HEADWATERS SUBDIVISION, UNIT TWO,
RESUBDIVISION OF LOTS 36 – 39 & 50

APPLICATION NUMBER 9 DATE February 6, 2014
APPLICANT Headwaters Subdivision, Unit Two, Resubdivision of Lots 36 – 39 & 50
REQUEST Subdivision

DETAIL SITE PLAN

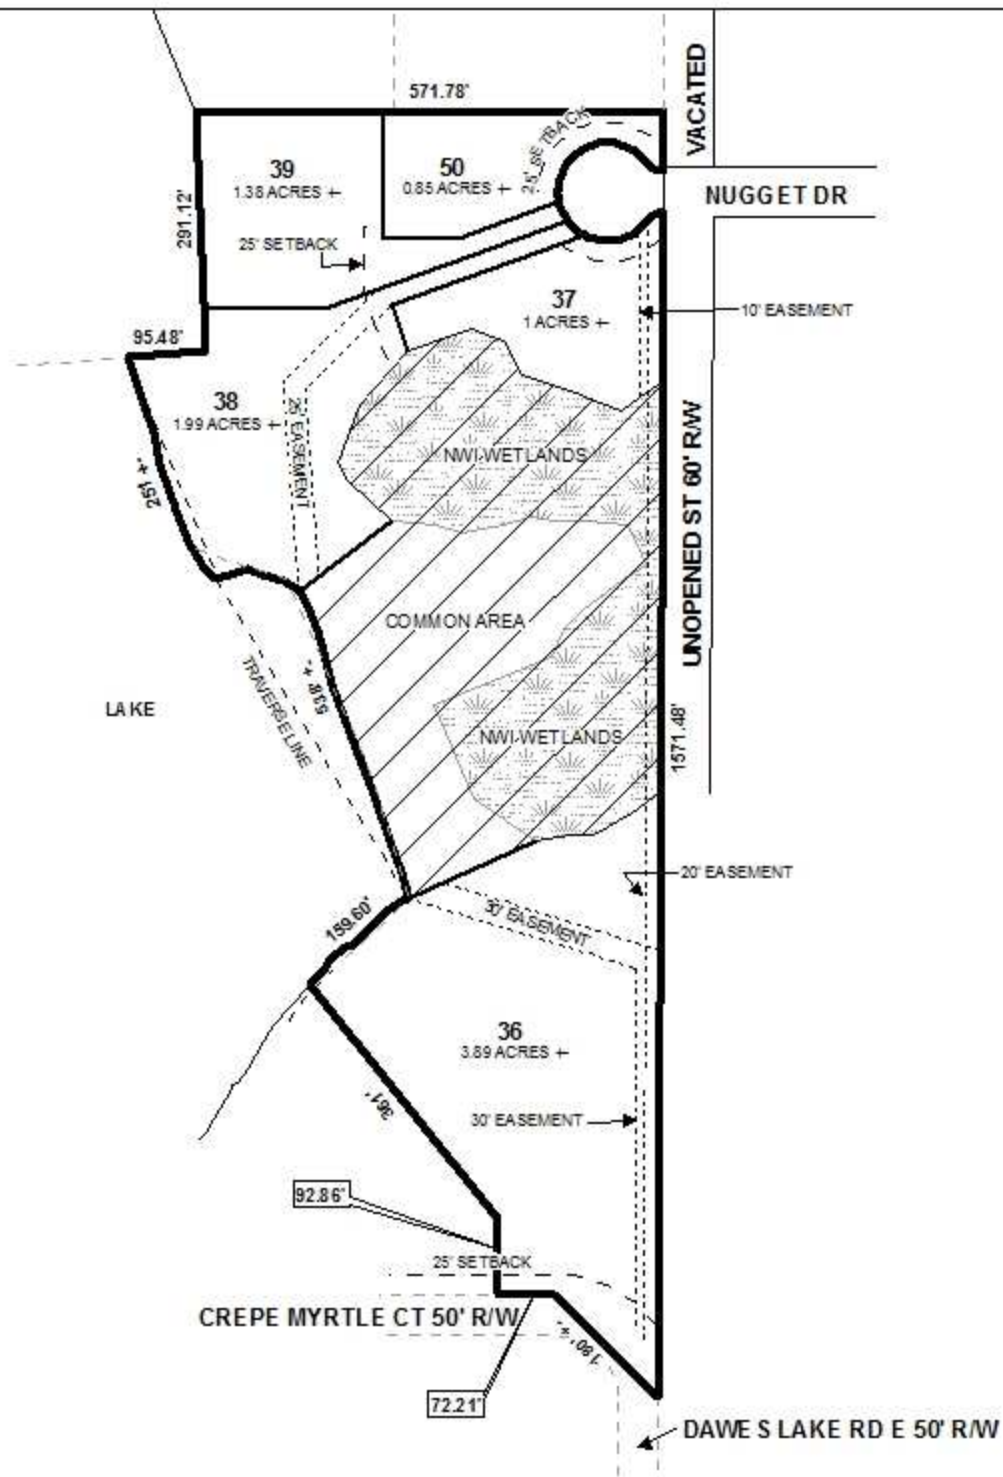
As on the preliminary plat the 25' minimum building setback line should be illustrated on the Final Plat. The plat should be revised to also illustrate a 30' minimum building setback line on Lots 36 and 37 along the unopened public right-of-way along the East side of the site, due to existing drainage and utility easements.

The plat labels each lot with its size in acres. This should be revised to also label each lot in both acres and square feet, or a table should be furnished on the Final Plat providing the same information.

Access management is a concern for all lots. Lot 36 is a corner lot and also contains an access easement to the Common Area within the interior of the subdivision. Therefore Lot 36 should be limited to two curb cuts, with one of the two for the Common Area access easement. Lot 37 is also a corner lot and a note should be placed on the Final Plat stating that Lot 37 is limited to one curb cut to the cul-de-sac and denied access to the unopened public right of way until such time it is developed to County standards. Lots 38, 39 and 50 should each be limited to one curb cut to the cul-de-sac. The size, design and location of all curb cuts should be approved by County Engineering and conform to AASHTO standards.

Due to the various easements within the proposed subdivision, a note should be required on the Final Plat stating that no structures are to be built within any easement. As the site is now proposed to have a Common Area, a note should be required on the Final Plat stating that the maintenance of the Common Area is the responsibility of the property owners. And as the site borders upon a lake and also contains NWI wetlands, this indicates that the area may be environmentally sensitive; therefore, the approval of all applicable federal, state and local agencies would be required prior to the issuance of any permits or land disturbance activities.

- 1) illustration of the 25' minimum building setback line along all street frontages;
- 2) revision of the plat to also illustrate a 30' minimum building setback line on Lots 36 and 37 along the unopened public right-of-way along the East side of the site, to accommodate existing drainage and utility easements;

- 3) revision of the plat to label each lot with its size in both acres and square feet, or the furnishing of a table on the Final Plat providing the same information;

- 4) placement of a note on the Final Plat stating that Lot 36 is limited to two curb cuts, with one of the two for the Common Area access easement;
- 5) placement of a note on the Final Plat stating that Lot 37 is limited to one curb cut to the cul-de-sac and denied access to the unopened public right-of-way until such time it is developed to County standards;

- 6) placement of a note on the Final Plat stating that Lots 38, 39 and 50 are limited to one curb cut each to the cul-de-sac;
- 7) placement of a note on the Final Plat stating that the size, design and location of all curb cuts should be approved by County Engineering and conform to AASHTO standards;

- 8) placement of a note on the Final Plat stating that no structures are to be built within any easement;
- 9) placement of a note on the Final Plat stating that the maintenance of the Common Area is the responsibility of the property owners;
